- A. Models 120-thru-470 Transom Assemblies with External Return Line Trim Cylinder
- B. Power Trim Pump Vent Screw and Washer

A. MODELS 120-thru-470 TRANSOM ASSEMBLIES with EXTERNAL RETURN LINE TRIM CYLINDER

Figure 1. Location of "X" on Piston Rod

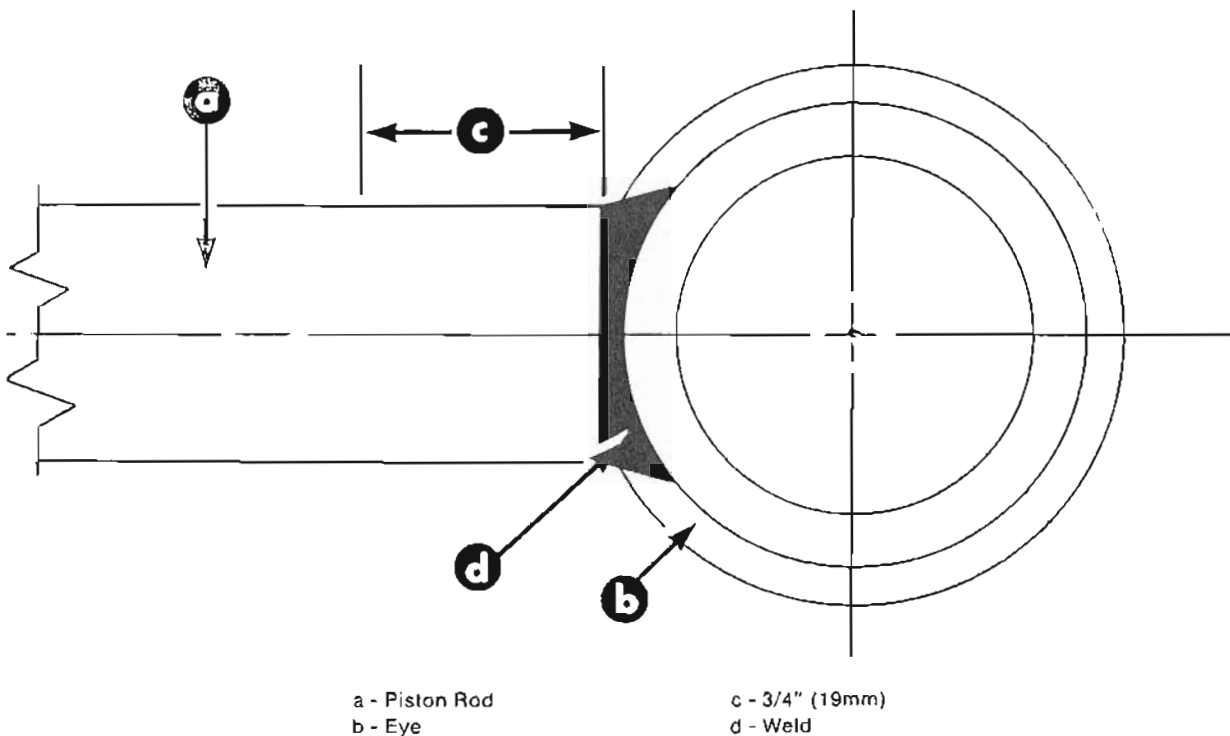
Models 120-thru-470 transom assemblies, Serial No. 05643699 thru 05644031, with external return line trim cylinders should have the trim cylinders replaced because of potential internal leakage.

Future transom production with external return line trim cylinders will have an "XO" or "O" stamped on piston rod approximately $\frac{3}{4}$ " (19mm) from the point that the eye is welded to rod. (Figure 1) Cylinders, which are marked with an "XO" or "O", NEED NOT BE replaced.

Since supplies of replacement external return line trim cylinders are limited, please replace all of these cylinders with Part No. B-45706A14 and Hydraulic Hose B-32-86036. Return removed cylinders (with warranty claim) to local Branch or Distributor for credit of replacement cylinders and hoses. Transom serial number must be included on warranty claim. Labor rate is 0.5 hours per transom assembly.

Figure 2. Vent Screw and Washer Location

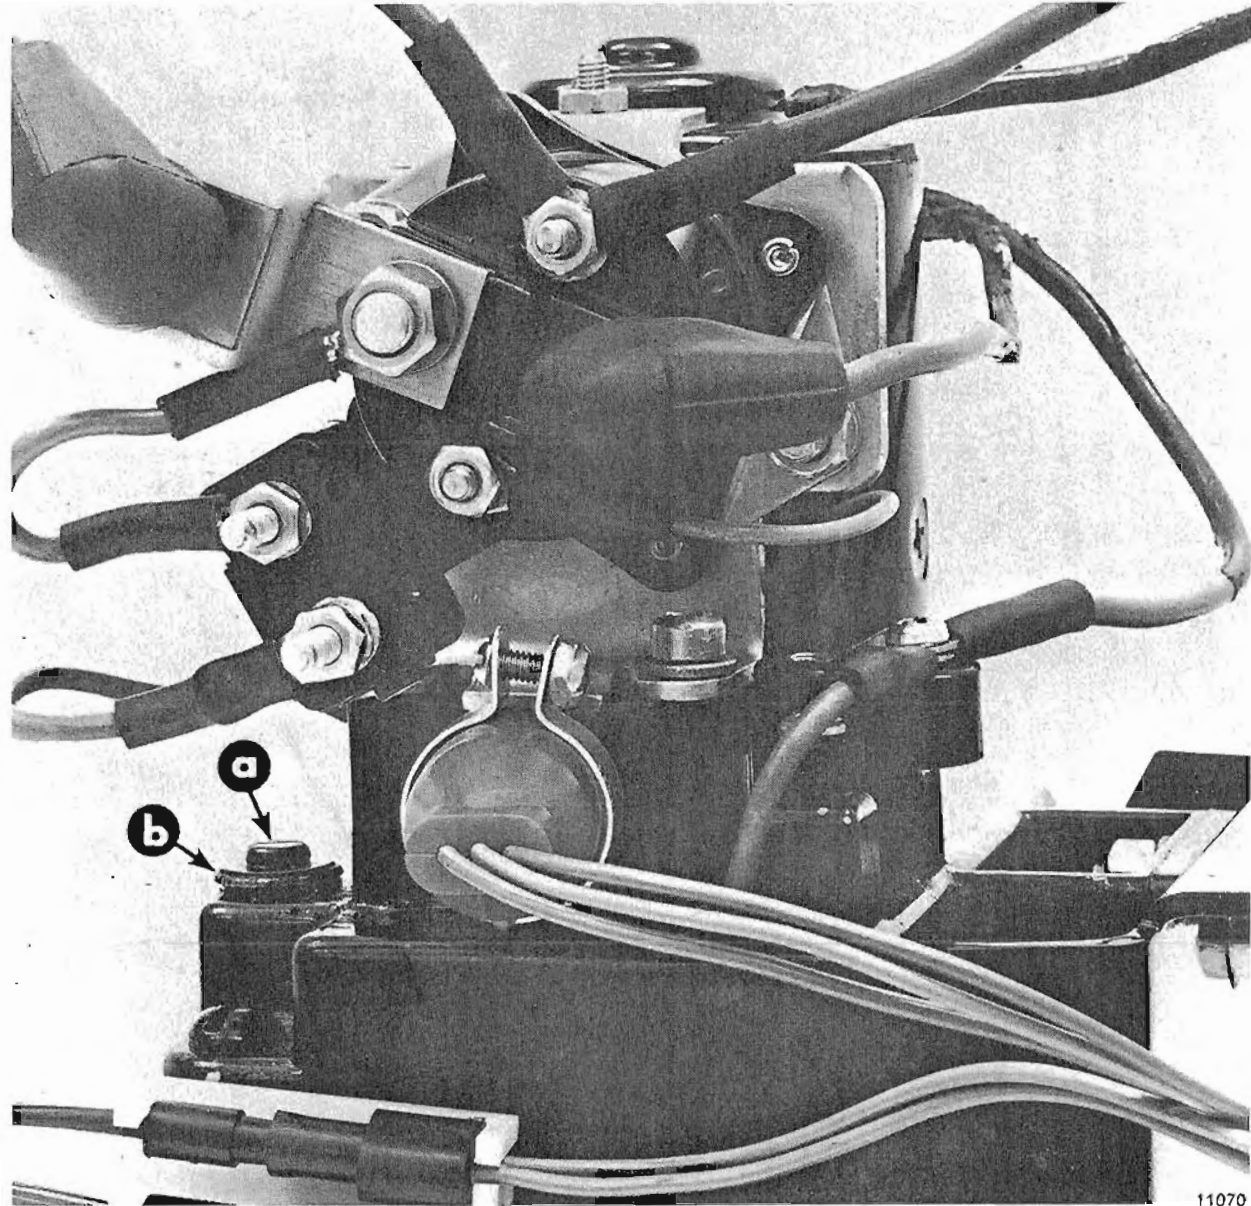
After installation of Power Trim pump, the vent screw (Figure 2) must be loosened 2 full turns for proper pump operation. However, for a short time a rubber washer was used on the vent screw. This washer will not allow the pump to vent sufficiently. The rubber washer, therefore, **MUST BE REMOVED** on all these trim pumps and the vent screw reinstalled and loosened 2 full turns.

b - Washer (Remove)
